S E R V I C E N O T E

6032A Autoranging DC Power Supply

Modification using RTV to prevent W8 Ribbon Cable disconnect.

Figure 1

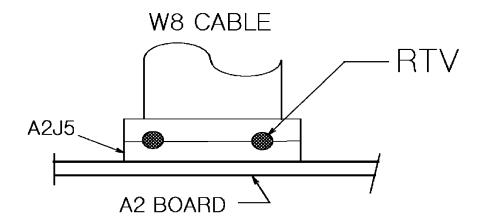
The W8 ribbon cable connecting the A1 main board assembly to the A2 Control board assembly may vibrate loose during transportation. This only involves units with serial numbers inclusive of those listed above.

Reconnect the W8 ribbon cable. Use RTV to secure the W8 connector to the J5 mating connector on the A2 assembly. Put a 8 mm (0.313 in) size spot bridging the W8 / J5 connectors. Bridge the connectors with an RTV spot at each end as shown in figure 1.
